ADDENDUM NO. 3

Date of Addendum: 2-10-2025

PROJECT NAME: Lake Houston Wilderness Park Cottages

PROJECT NO: WBS No F-HAR014-0001-4-01-01 ; F-HAR014-0001-4-01-02

P1-01
SCALE: As indicated

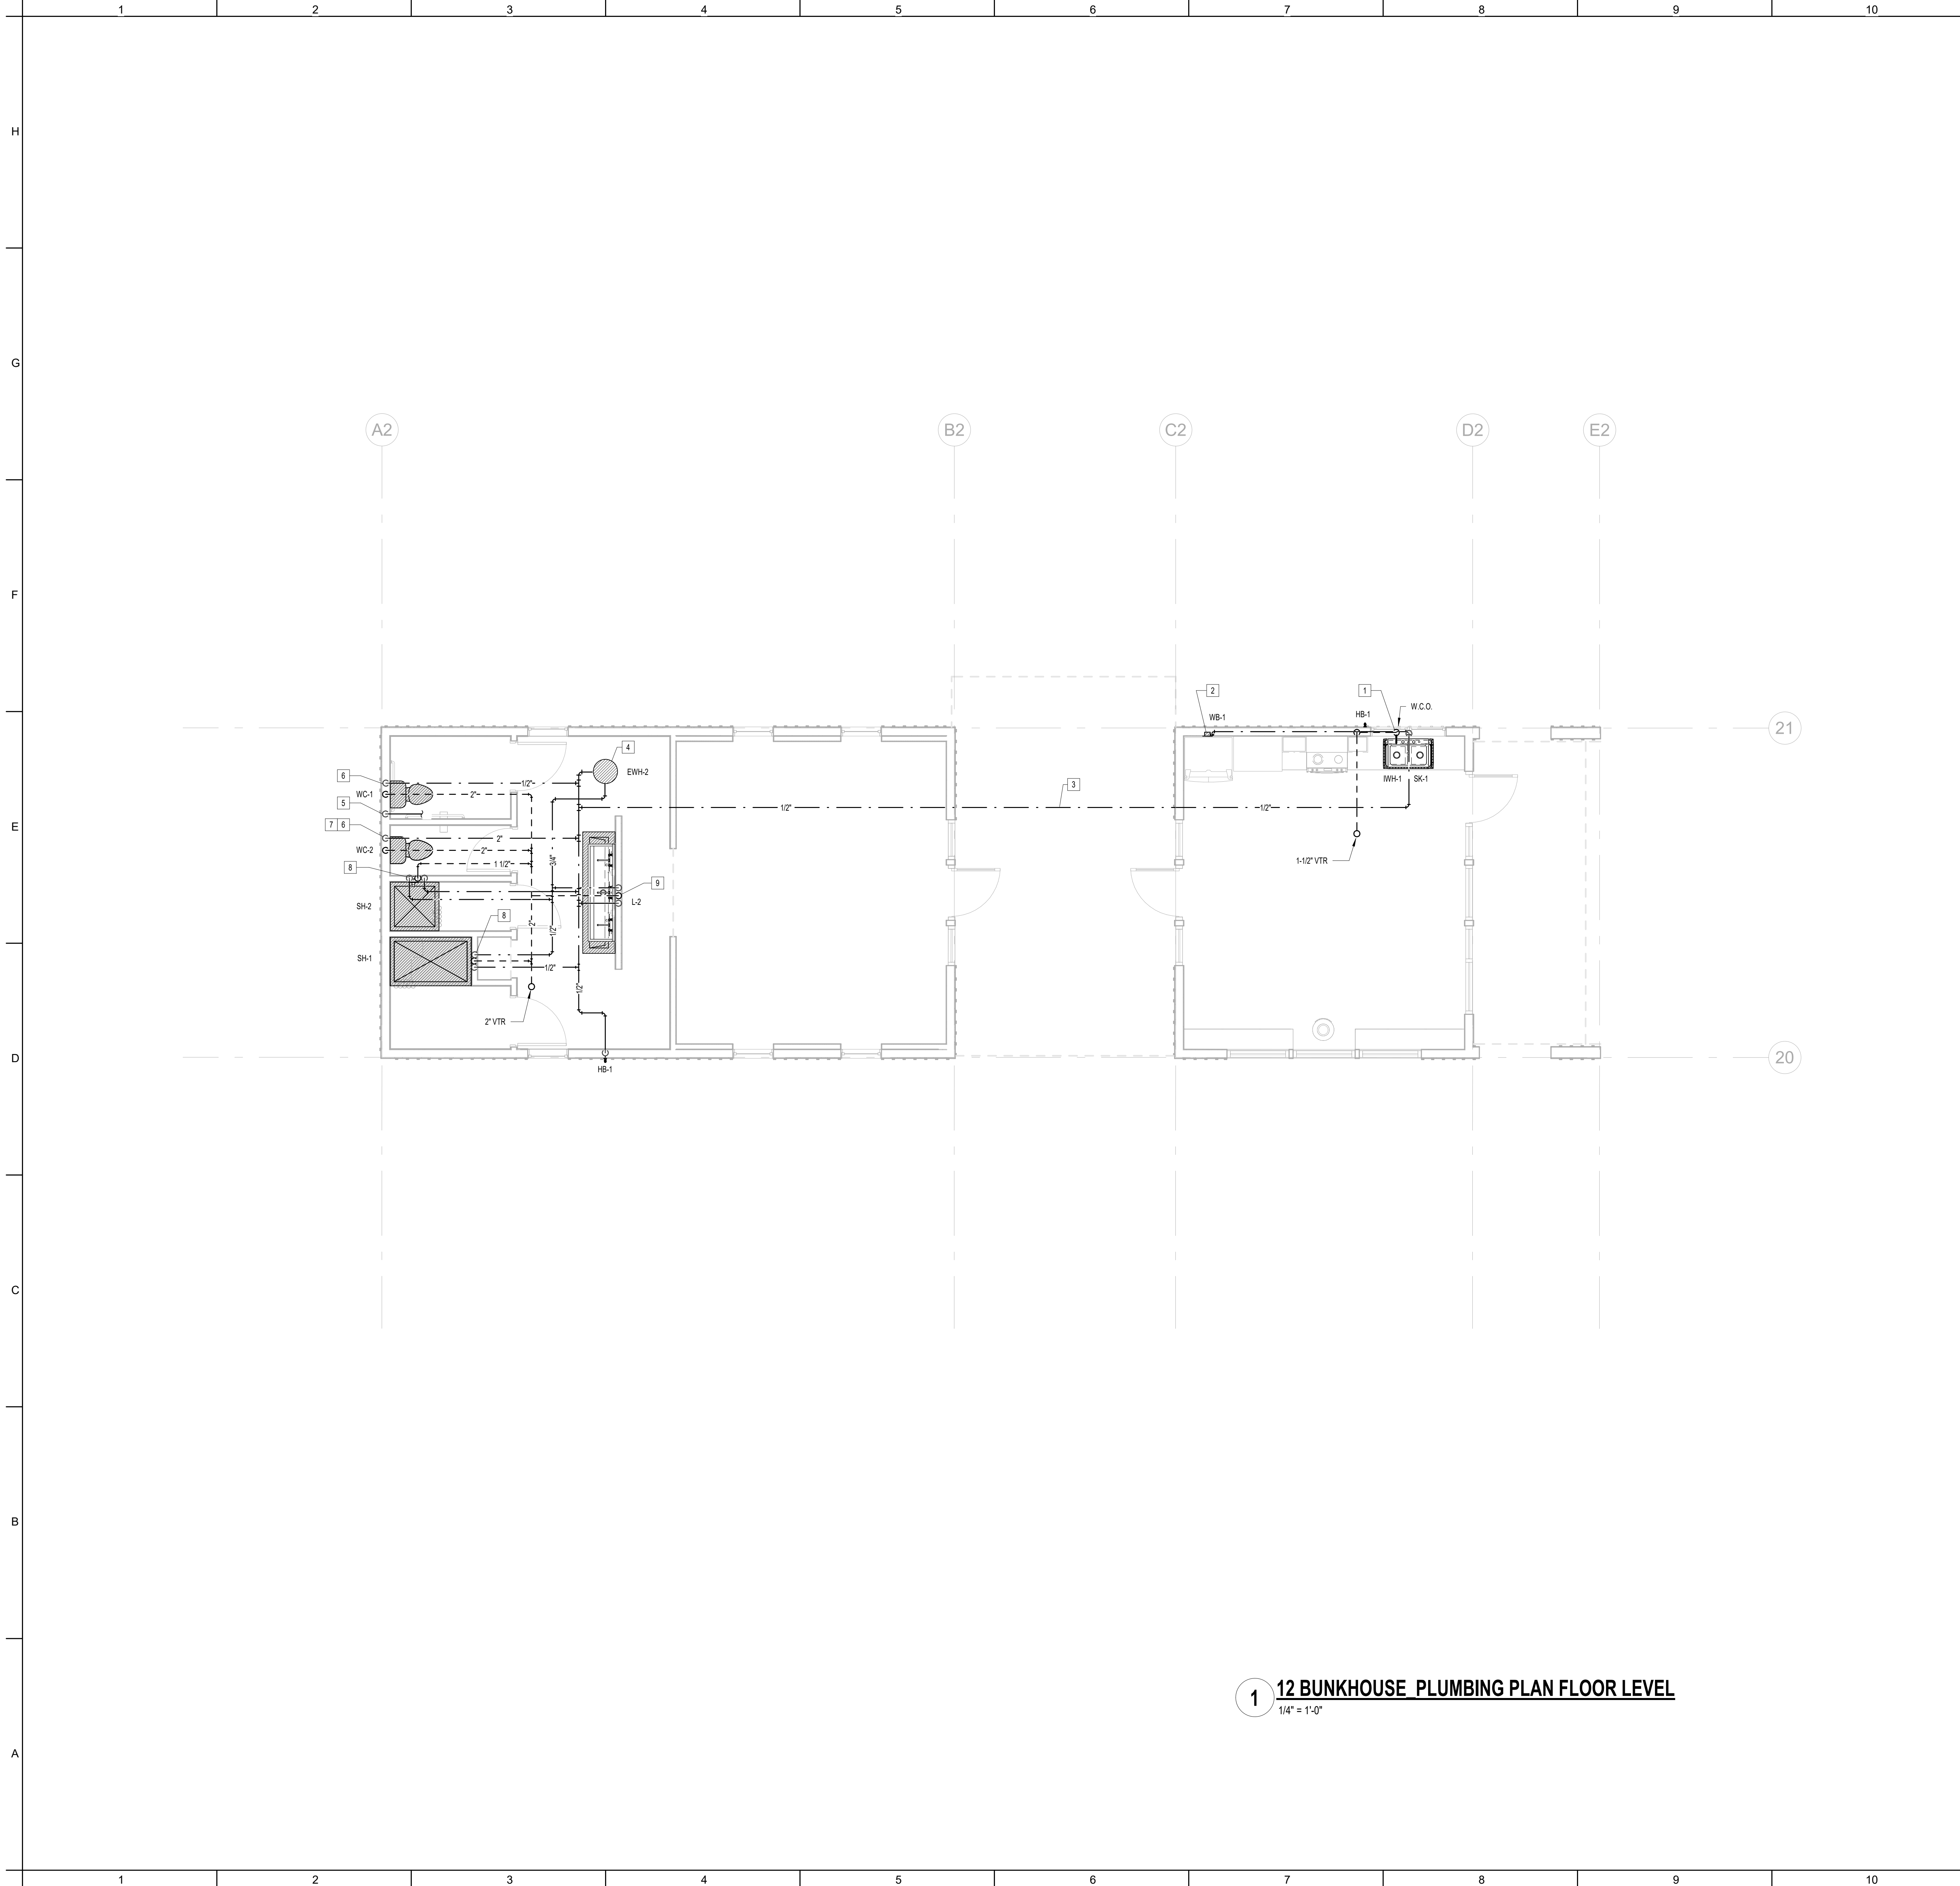
11. P1-01- PLUMBING PLAN - #24 BUNKHOUSE, Add and replace with new sheet which: Added note clarifying Fire Sprinkler System requirements; updated Note 6 to clarify water flow detection alarm
